APPLICATION FOR PERCOLATION TESTING AND SITE EVALUATION

SUBDIVISION/PROPERTY NAME La Casa De Rosa Residential Care Facility

SEWAGE DISPOSAL SYSTEM SPECIFICATIONS WORKSHEET

Re: **Percolation Test Report**
11520 Johns Hopkins Rd.
Clarksville, MD 21029

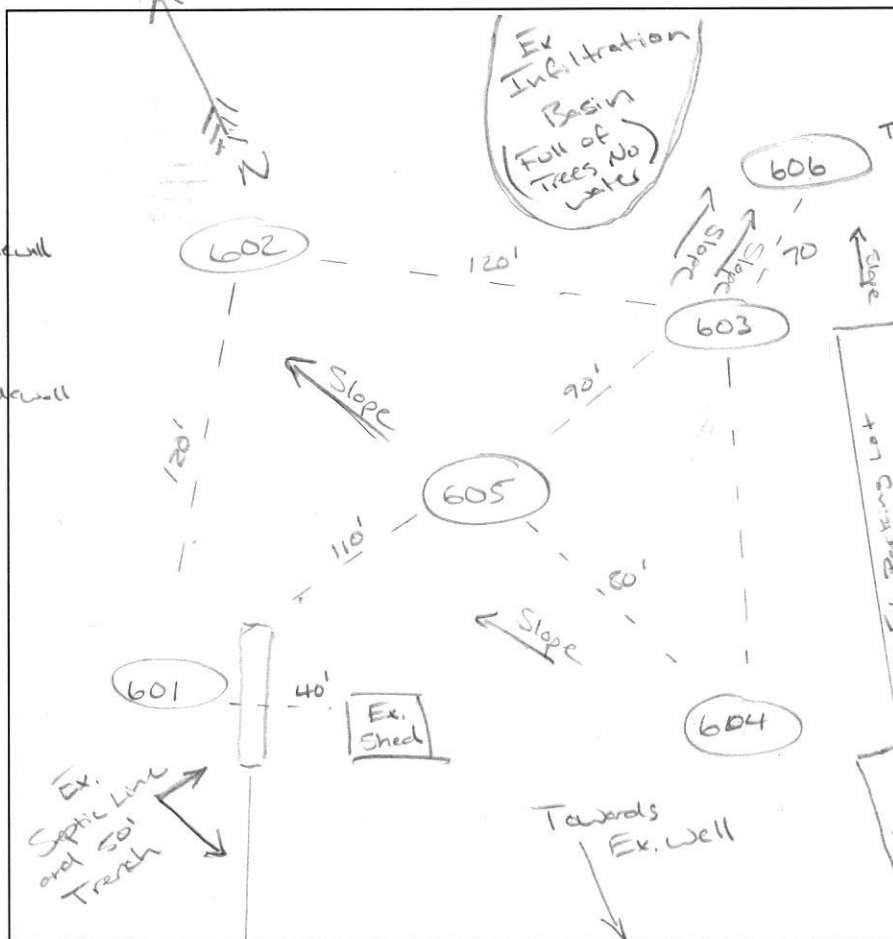
Avoid holes 604 + 601 due to heavy clay content and compact sand. If holes must be used effective area is 6'-8' @ 1.2 rate. Area North of parking lot may use effective area between 4'-8' @ 1.2 rate. (Holes 606 - 608)

603 + 605 Initial system: Application rate: 0.8 Effective area beginning depth: 4 Bottom maximum depth: 8
603 + 605 + 602 1st Replacement: Application rate: 1.2 Effective area beginning depth: 4 Bottom maximum depth: 8
605 + 602 2nd Replacement: Application rate: 1.2 Effective area beginning depth: 4 Bottom maximum depth: 8
